"WINDRIDGE ESTATES"
SEDGWICK COUNTY, KANSAS

RE: S/D 96-1 - Final Plat of WINDRIDGE ESTATES ADDITION

CASE NUMBER: S/D 96-1 WINDRIDGE ESTATES

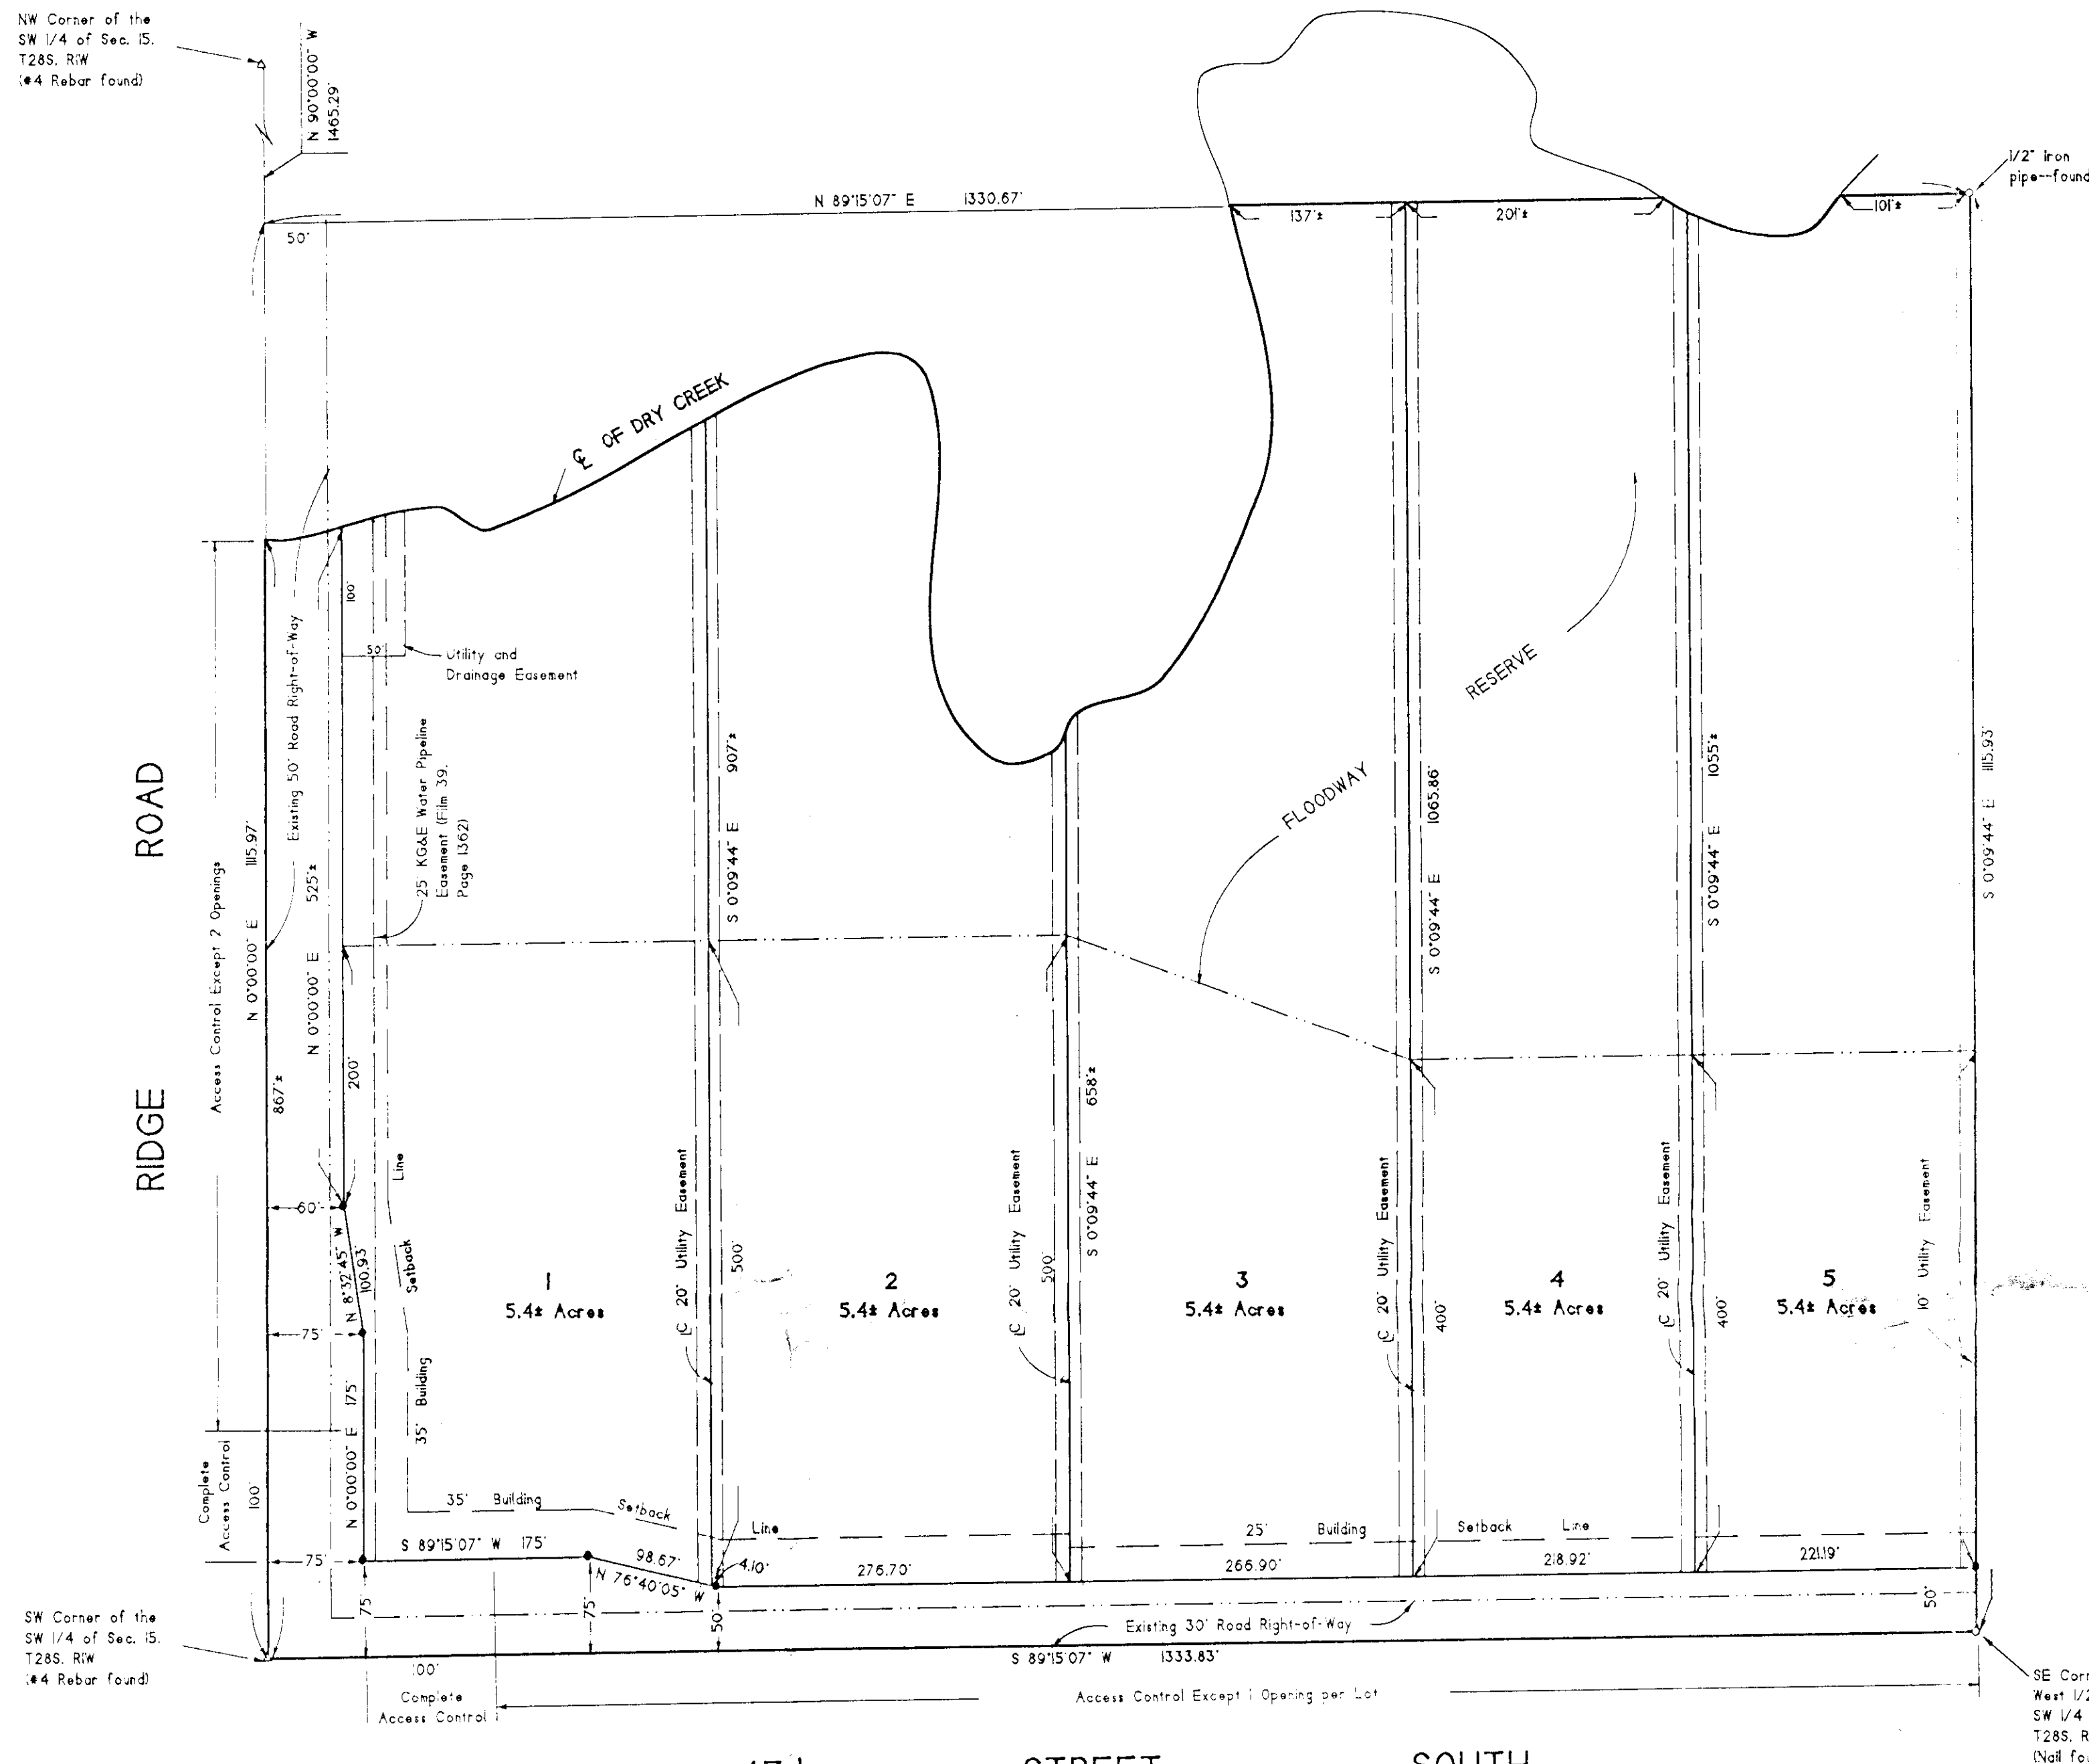
D. The applicant is advised that it is not typically recommended that a portion of a lot, such as the northern segment of Lot 4, be platted in such a manner when access to such a piece is not reasonably available. In this case, this segment of Lot 4 is isolated from the buildable area of the lot by a pond.

1. *I changed*
The MAPC signature block shall indicate Susan Osborne-Howes as Chairman.

2. Lot lines should be shown as the most distinct or bolder of the lines on the plat. The center lines for Ridge and 47th Street South shall therefore be made less distinct and/or shown as dashed lines. Also, the terminus of these streets (rights-of-way) at the north and east lines of the site should also be shown as fainter, dashed lines. Solid lines are used to imply a private street (Reserve).
